# Crookwell 2 Wind Farm

## Response submission to DPE comments- Heritage Modification 2 Amendment to Development Consent DA 176-8-2004i

16 May 2017

Prepared for Crookwell Development Pty Ltd

Figure 1. Management Actions

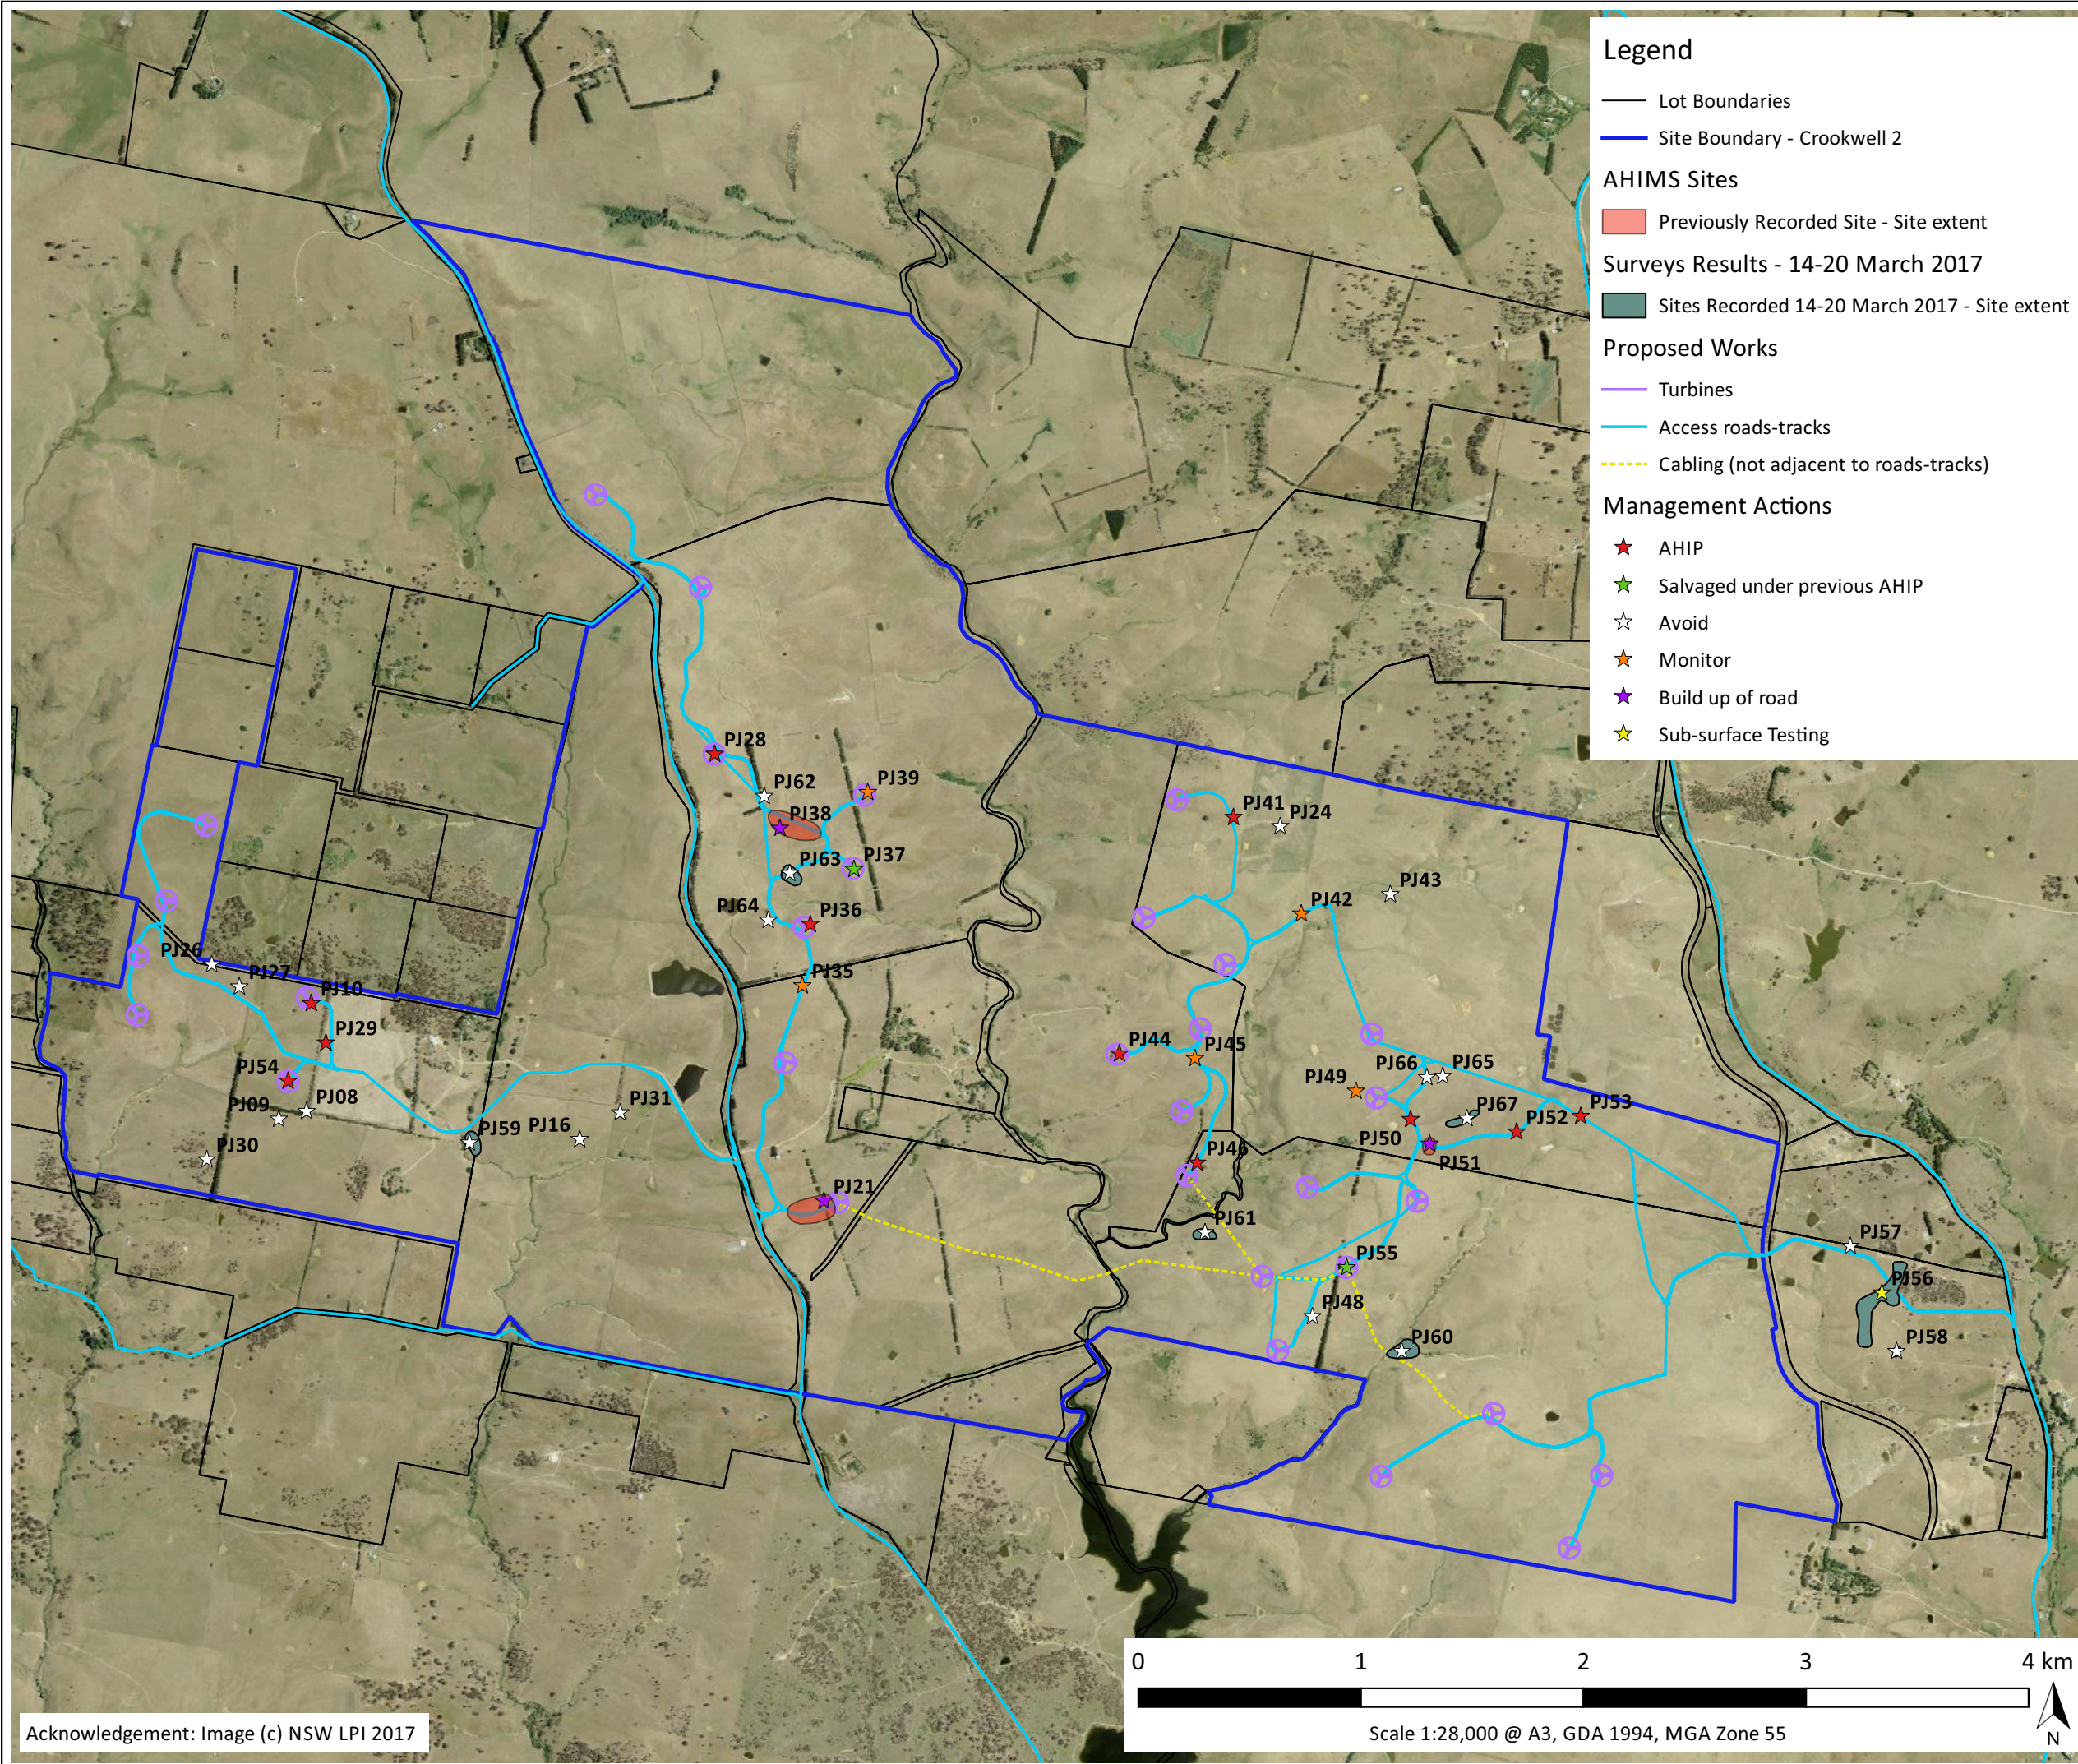
- A map showing the location of the remaining turbines, cabling, laydown areas and access tracks in relation to the known archaeological sites.
- Clarification as to whether archaeological sites were actually impacted under previous permits. If not, AHIPs would need to be applied for, supported by a current Aboriginal Cultural Heritage Assessment, including an archaeological report.
- Advised recommencement of a process of consultation with Aboriginal stakeholders as required to support an AHIP application.
- Advised that an Aboriginal Heritage Management Plan (AHMP) should be developed prior to construction.
- Advised that field survey of the new sections of re-alignment should be undertaken.

In summary, a total of 38 sites are within the vicinity of the current Modification 2 application. Of these 38 sites, 15 can be avoided by the works, and 2 have been salvaged under AHIPs, leaving 21 sites to be impacted. Of these 21 sites, 20 have been tested in the 2005 program with a representative sample collected. One newly recorded site requires further assessment to quantify impacts.

Of these 38 sites, 21 (as shown in Table 2) are proposed for impact under an AHIP. 12 have no further mitigation measure, due to their small, subsurface nature. Five are considered to hold moderate significance and should be subject to cultural monitoring of topsoil removals and collection of any artefacts. The remaining three areas of PAD are considered to be high in scientific values should be subject to cultural monitoring and build-up of the road construction area (limited to 6m in width) as they have been subject to subsurface investigation previously.

One new site (PJ56) requires subsurface investigation to determine the degree of impact. Until this work has been undertaken no impacts can occur to the site.

Figure 1 shows the location of heritage sites that will be impacted under the current Mod-2 application with their recommended management actions.
